DOUTHIT #1 PC
UNIT C SECTION 26 T27N R11W
San Juan County, New Mexico
P & A Procedure

Re: Permanent Abandonment

Well: #1 D-411

CONDITIONS OF APPROVAL

DOUTHIT #1 PC

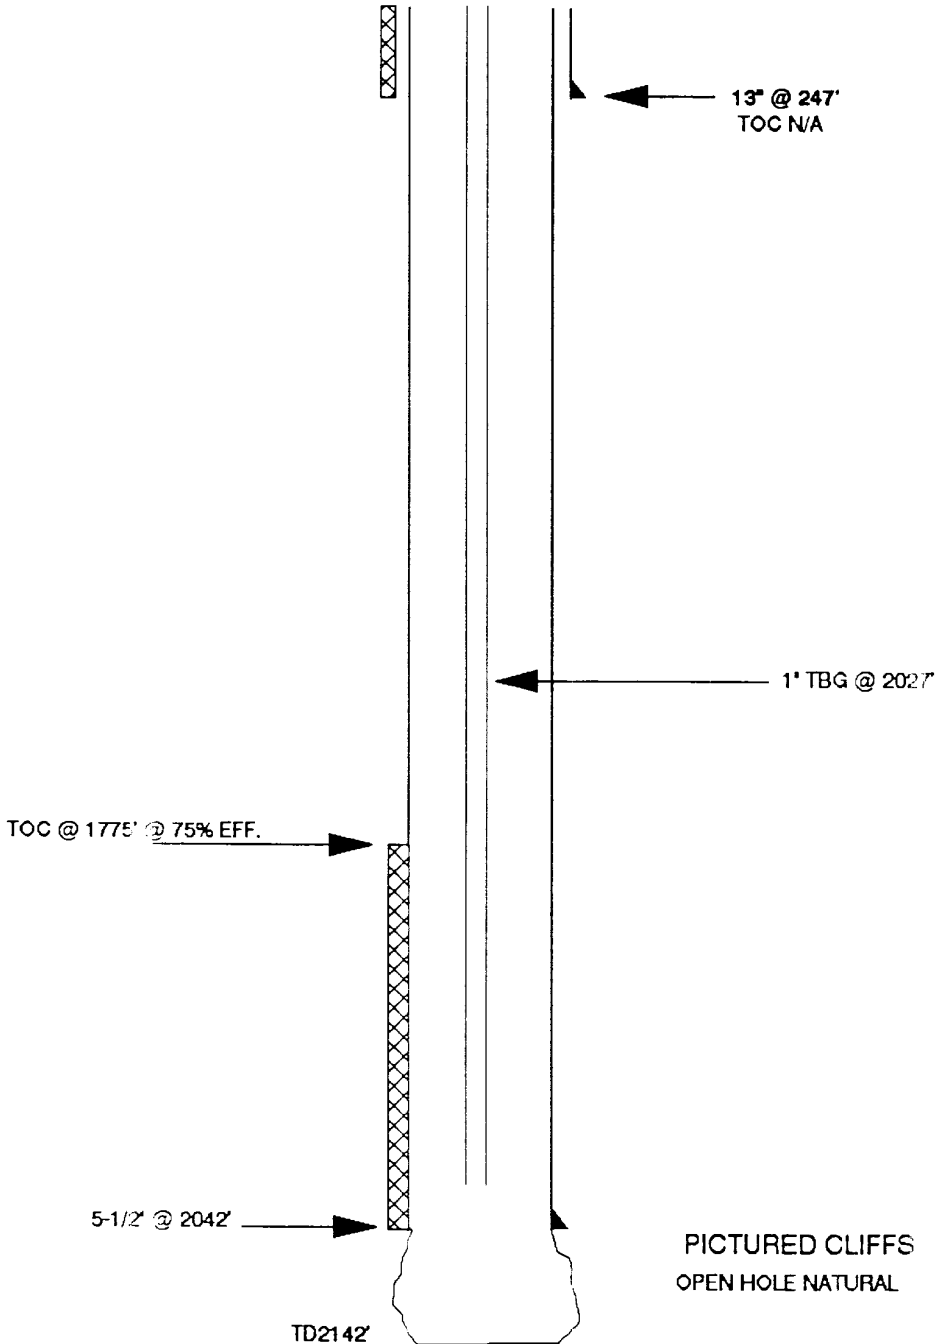
1) If cement has not circulated, perforate @ 297 (5' below surface csg) and circulate cement to the surface. If cement has circulated, spot a cement plug from 297 to surface in the 5' csg.
